# Access Compliance Report

## Public Rights-of-Way

Intersection ID: 24827	Main Street: ARBORETUM_DR	Cross Street: PINEVILLE-MATTHEWS_RD	Location: S
ADA ID: 901C67DCC600	Ramp Type: PerpDiag	Initial Pass/Fail: Fail	Overall Compliance: No
Codes/Mitigation Info/Possible Solution		Field Measurements/Component Compliance	
Severity Score: 21.25

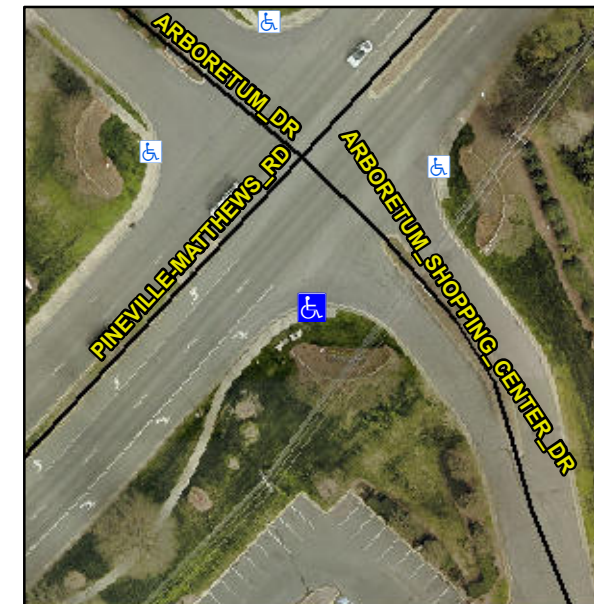
**Not Found, R304.5.1, R304.2.2**

Compliance	Description	Data	Compliance	Description	Data
N/A	Ramp Length (in)	60.0	No	Ramp Slope (%)	10.2
No	Ramp Width (in)	39.0	Yes	Ramp XSlope (%)	0.4
N/A	Flare Type LT	N/A	N/A	Flare Type RT	N/A
N/A	Flare Slope LT (%)	N/A	N/A	Flare Slope RT (%)	N/A
N/A	Flare Traversable LT?	N/A	N/A	Flare Traversable RT?	N/A
N/A	Landing Length (in)	N/A	N/A	DWS Provided?	N/A
N/A	Landing Width (in)	N/A	N/A	DWS Contrast?	N/A
N/A	Landing Slope (%)	N/A	N/A	DWS Length (in)	N/A
N/A	Landing X Slope (%)	N/A	N/A	DWS Full Width?	N/A
N/A	Landing Curb? (Y/N)	N/A	N/A	DWS Offset (in)	N/A
N/A	Shared Landing?	N/A			
N/A	Gutter Ponding?	Yes	N/A	Gutter Slope (%)	N/A
N/A	Gutter Lip Ht (in)	N/A	N/A	Gutter X Slope (%)	N/A
N/A	Painted X Walk1?	No	N/A	Painted X Walk2?	No
	X Walk 1 Direction	To NE		X Walk 2 Direction	To NW
N/A	X Walk 1 Width (in)	N/A	N/A	X Walk 2 Width (in)	N/A
	X Walk 1 Slope (%)	4.2		X Walk 2 Slope (%)	2.8
	X Walk 1 X Slope (%)	2.5		X Walk 2 X Slope (%)	4.8

**Remove & Replace Curb Ramp With Two New Directional Ramps or Equivalent.**
